# Final Supplemental Environmental Impact Statement for the Nuclear Facility Portion of the Chemistry and Metallurgy Research Building Replacement Project at Los Alamos National Laboratory, Los Alamos, New Mexico

**Title:** *Final Supplemental Environmental Impact Statement for the Nuclear Facility Portion of the Chemistry and Metallurgy Research Building Replacement Project at Los Alamos National Laboratory, Los Alamos, New Mexico (CMRR-NF SEIS) (DOE/EIS-0350-S1)*

Figure 3-5 Mapped Faults in the Los Alamos National Laboratory Area

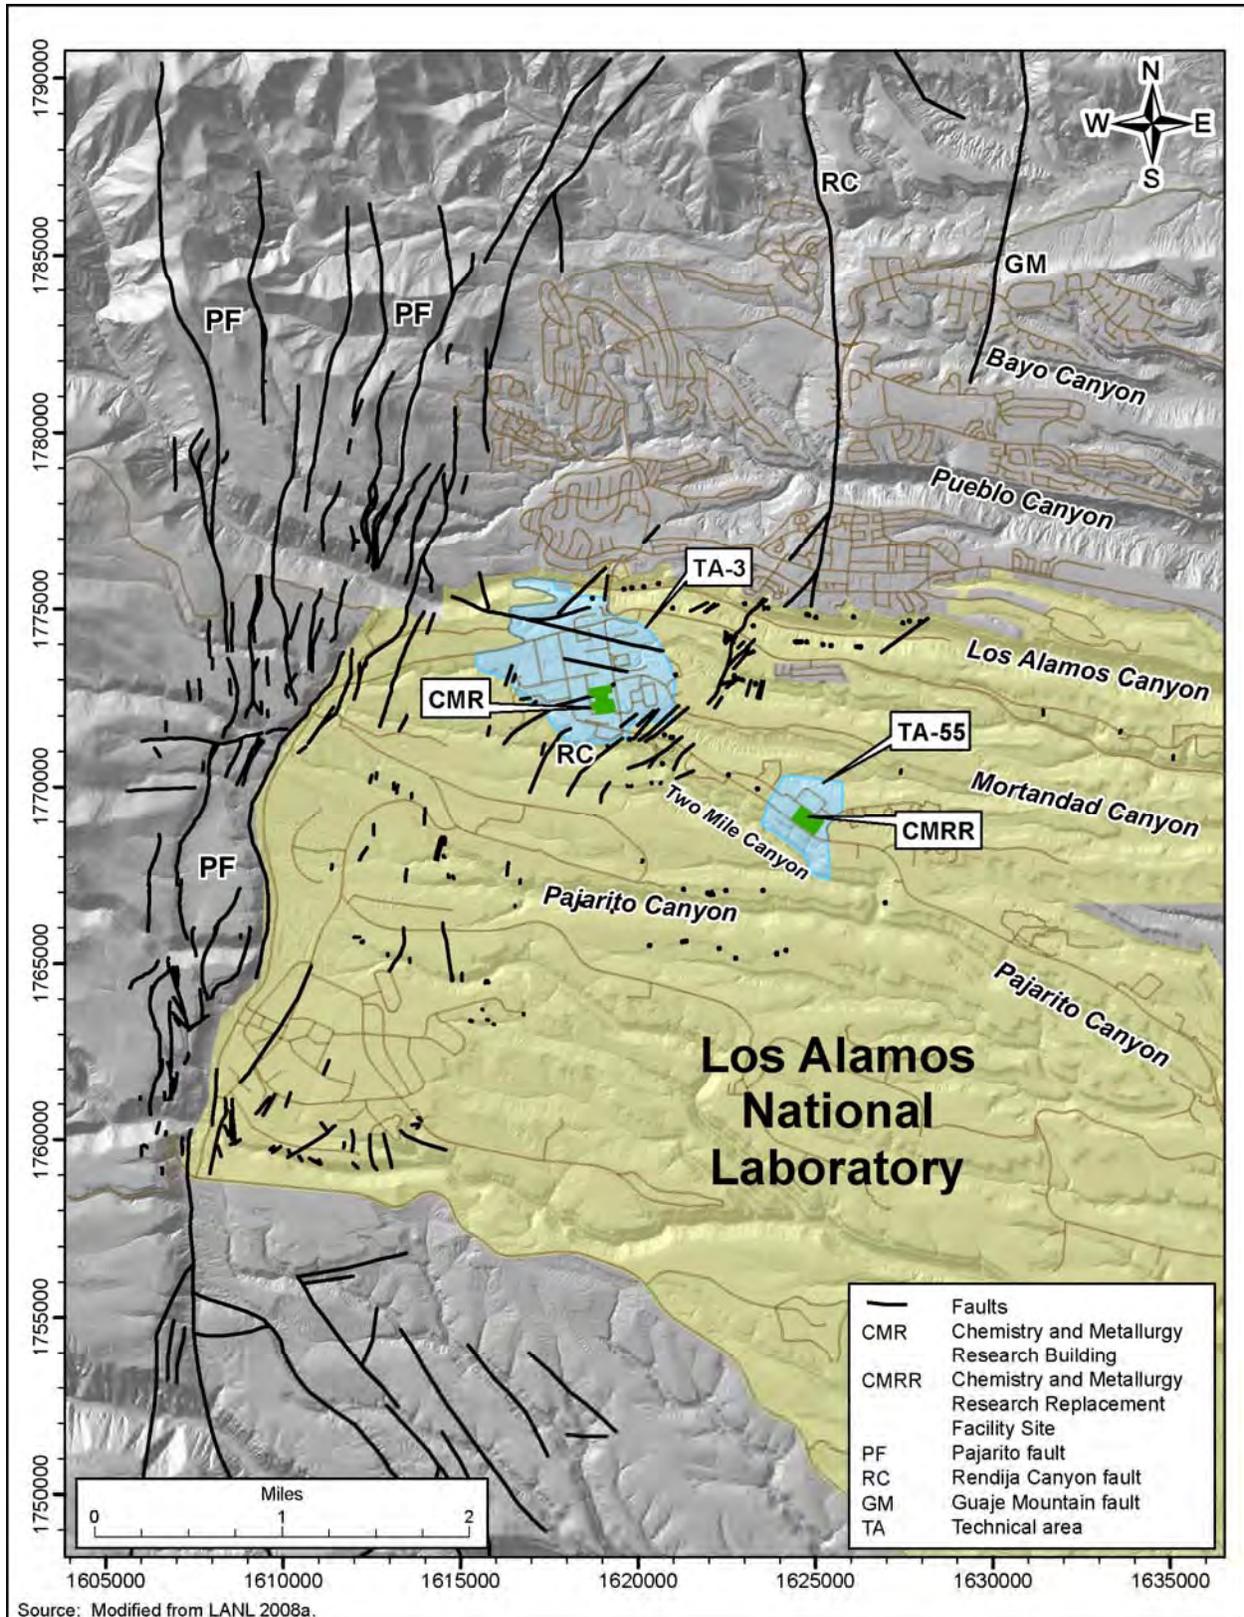
Although project areas TA-3 and TA-55 have been mapped in detail for the presence of faults, areas showing no faulting on dSEIS Figure 3-5 do not necessarily represent an absence or lack of faulting. Large eastern and southern areas of LANL have not yet been mapped in detail for seismic hazards. Additionally, faults are only shown in areas where such faults are exposed or inferred. The end of a fault line on a map does not necessarily indicate

Figure 1. Map of the Pajarito Fault System and Embudo Fault System – Southwestern Section in Northern New Mexico. **Source:** Figure 5-4 in LANL 2007 PSHA Report.

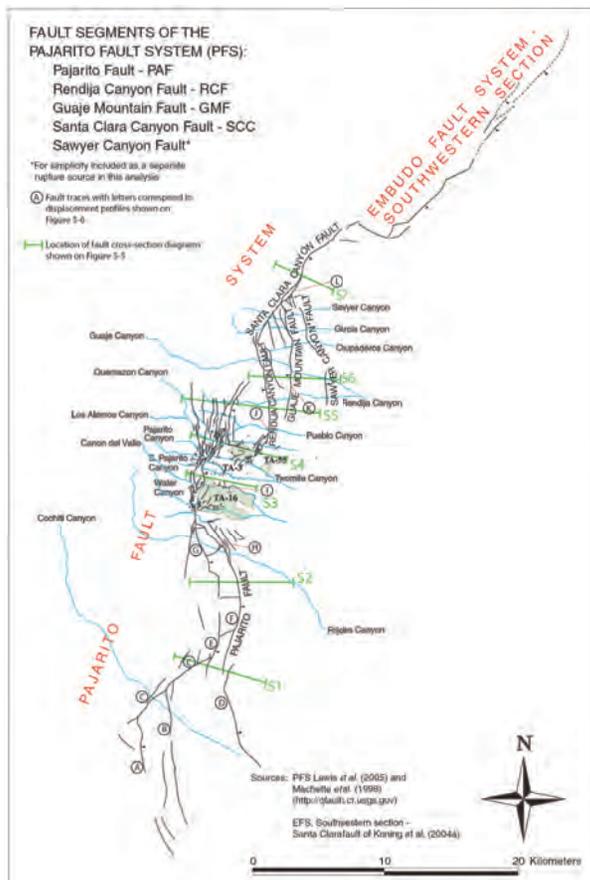
Figure 1 above on page 7 shows the network of fault segments in the PFS where the LANL Seismic Hazards Geology Team recommends a robust kinematic model. Our review shows that the knowledge required for a robust kinematic model does not exist. Accurate knowledge is necessary of 1), the locations of the discrete faults, 2), the geometry in the subsurface of the discrete faults, and 3), the potential linkage among the discrete faults for purposes of seismic hazard analysis at the location of the proposed CMRR-NF at LANL TA-55 and at other LANL critical facilities. The location of the proposed CMRR-NF is displayed above on Figure 2.

Figure 2. Mapped Faults in the Los Alamos National Laboratory Area.  
Source: Figure 3-5 in the DOE 2011 SEIS for locating the proposed CMRR  
Nuclear Facility at LANL TA-55.

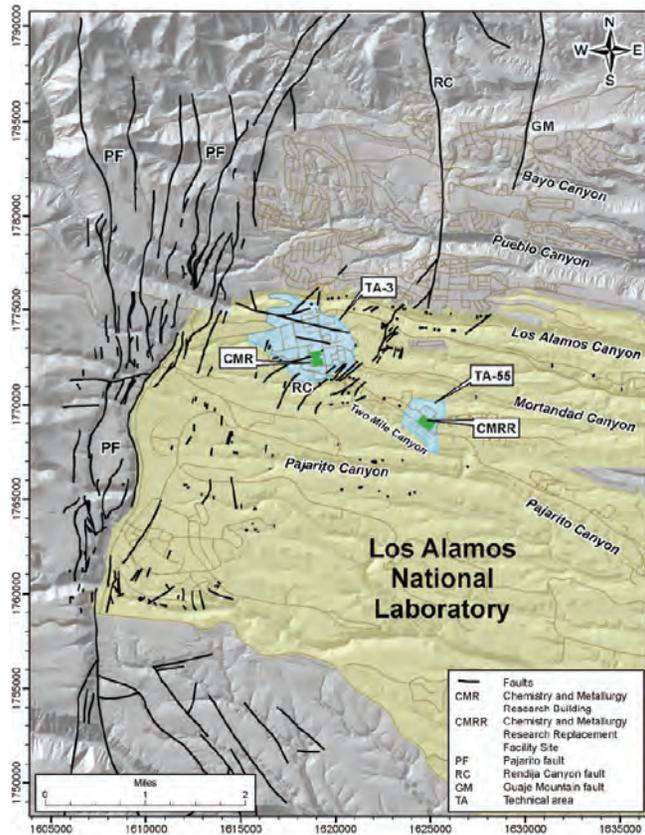
Comparison of Figures 2 and 3 shows that there is disagreement between the LANL scientists on the location of active faults close to the proposed CMRR-NF at LANL TA-55. The fault locations of Figure 2 are based on mapping of fault displacements from field investigations by LANL scientists on the Seismic Hazards Geology Team. The fault locations on Figure 3 are based on mapping of intense zones of fracturing in field investigations by LANL scientist Kenneth H. Wohletz (Wohletz, 2004). Some of the intense zones of fracturing are associated with large displacement faults. However, faults are not identified in the upper part of the Bandelier Tuff for the intense zones of fracturing on Figure 3 that are located close to the proposed CMRR-NF. The issue of the zones of intense fracturing mapped by Wohletz is Issue 1.D on page 34.

Figure 2 shows the numerous fault splays that are mapped at the southern end of the RCF. The above statement in Lewis et al., 2009 indicates that the LANL Seismic Hazards Geology Team have a concern that the GMF could extend south to a location close to the proposed CMRR-NF. Nevertheless, the necessary detailed field mapping for accurate knowledge of the southern extent of the GMF to determine proximity to the location of the proposed CMRR-NF has not been performed.

The design of the proposed CMRR-NF was based on the locations of faults shown on Figure 2. Accordingly, the distance of the proposed CMRR-NF away from faults was described in the DOE 2011 draft SEIS as follows on page 3-25:

**Comment by Gilkeson and Arends.** *In fact, accurate knowledge of the distance from the proposed CMRR-NF to the active Guaje Mountain Fault (GMF) does not exist according to Lewis et al., 2009 and comparison of Figures 2 and 3 shows there is disagreement among the LANL scientists on the distance from the CMRR-NF to the active Rendija Canyon Fault (RCF) and to the GMF.*

Figure 3. Map in 2004 LANL Report by Wohletz showing proposed location of Rendija Canyon Fault along the western boundary of LANL TA-55 and Guaje Mountain Fault 2500 feet east of the eastern boundary of TA-55.  
Source: Figure 14 in Wohletz, 2004 (LA-UR-04-8337).

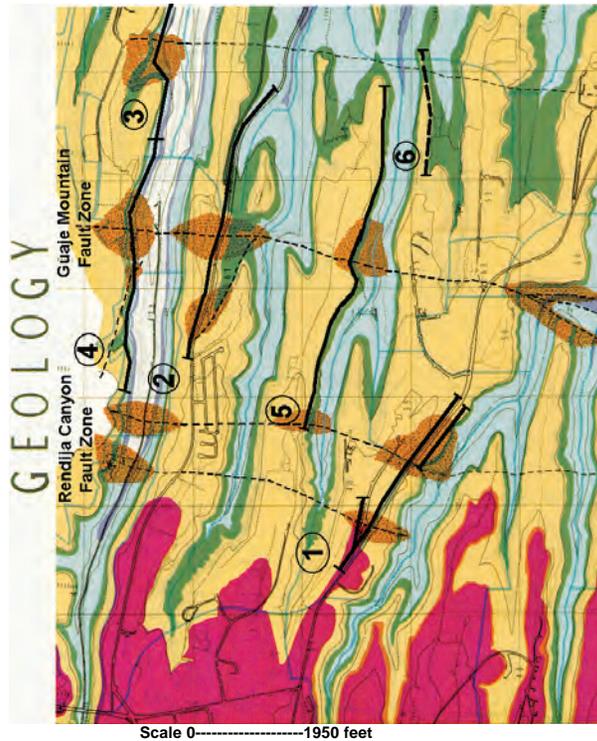
Geology Team have a concern that the GMF could extend south to a location close to the proposed CMRR-NF. The intense fractures mapped north of the proposed CMRR-NF in Mortandad Canyon and west of the NF on Figure 3 (Wohletz, 2004) may be caused by faults that are buried in the Bandelier Tuff that are now propagating up through the Bandelier Tuff (see discussion on page 37 in this report). Nevertheless, the necessary detailed field mapping for accurate knowledge of the southern extent of the GMF to determine proximity to the location of the proposed CMRR-NF has not been performed.

Figure 4. West to East Cross-Section D-E' on page 263 in Lewis et al., 2009.

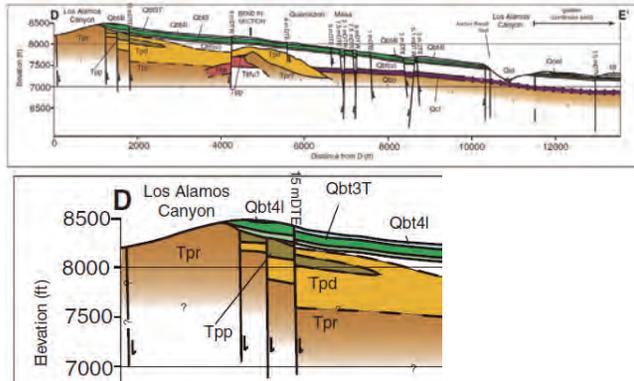
Figure 4 below is cross-section D-E' on page 263 in Lewis et al., 2009 that illustrates the large number of faults in the PFS that have propagated upward through the Bandelier Tuff. The enlarged view of the western part of cross-section D-E' shows three parallel faults where two of the faults do not propagate upward through the Bandelier Tuff. The two faults have been inactive for the past 1.25 million years.

**Figure 7-53.** Comparison of the larger seismic hazard from synchronous versus simultaneous surface-eruption earthquakes at the proposed CMRR-NF at LANL TA-55  
**Source.** Figure 7-53 in LANL 2007 PSHA Report.

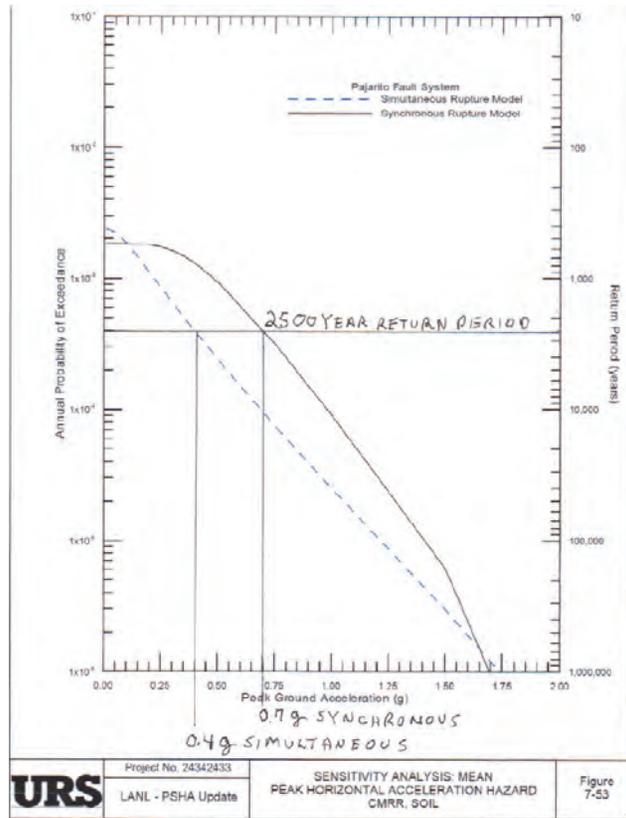
**Figure 7-53** shows a much higher horizontal ground acceleration of 0.7g for synchronous ruptures of the PFS at the location of the proposed CMRR-NF compared to a lower value of 0.4g for simultaneous ruptures of the PFS.

Figure 7-53 shows that the Mean Peak Horizontal Acceleration Seismic Hazard at the proposed CMRR-NF is 75% higher for the ground-surface ruptures from multiple synchronous earthquakes in the PFS for a return period of 2,500 years at 0.7g than for the simultaneous ruptures from a single earthquake for the same return period at a lower value of 0.4g.
